DRAWING CHANGES

REMARKS

This Application has been carefully reviewed in light of the Office Action mailed March 29, 2005. At the time of the Office Action, Claims 1-21 were pending in this Application. Claims 13-21 were allowed. Claims 1, 3, 5-7, 9, 11 and 12 were rejected, and Claims 2, 4, 8 and 10 were objected to. No amendments have been made in this response. Applicants respectfully request reconsideration and favorable action in this case.

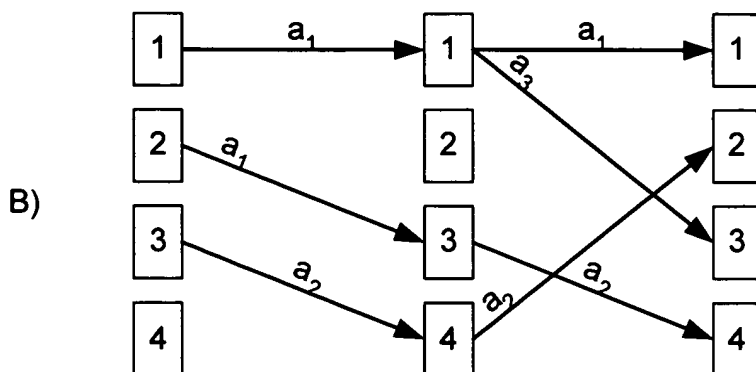
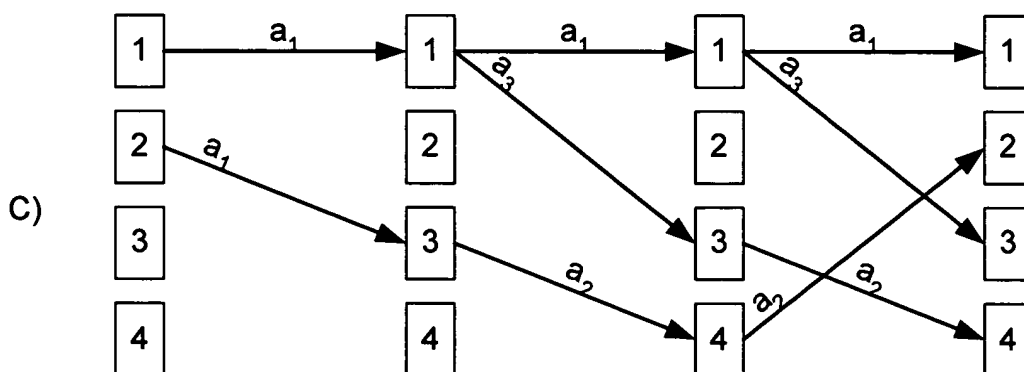
In the second pass, the second element is analyzed in a similar way. However, the elimination step now includes the previous trellis as shown in Fig. A) Again, all distances are calculated and then the resulting distances through the two-step trellis are used and the shortest distances determine the transitions that are kept. Thus, in this example, the transition from state 3 to state 2 in Fig. A is eliminated. The result is shown in Fig. B).

The last pass repeats these steps for the last symbol. The elimination process affects the previous two trellis by eliminating the transitions from state 3 to state 4 to state 2 in Fig. B). The resulting three-way trellis is shown in Fig. C) below:

FIG. 1
(PRIOR ART)

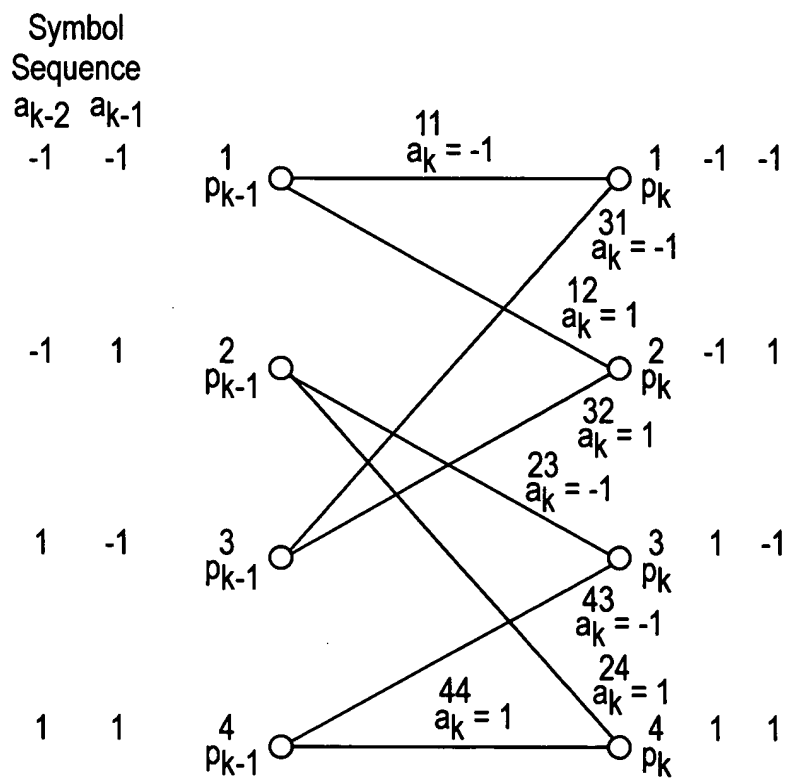
Examiner has objected to the drawings for not showing every feature of the invention specified in the claims under 37 CFR 1.83(a). Applicant submits corrected drawings in compliance with 37 CFR 1.121(d). Figures 1 and 2 have been identified as prior art. Applicants have also reordered the drawings so that Fig. 2 is below Fig. 1 instead of Fig. 7.

The Examiner has objected to the drawings for not showing every feature of the invention specified in the claims under 37 CFR 1.83(a). Applicant submits corrected drawings in compliance with 37 CFR 1.121(d). Figures 1 and 2 have been identified as prior art.
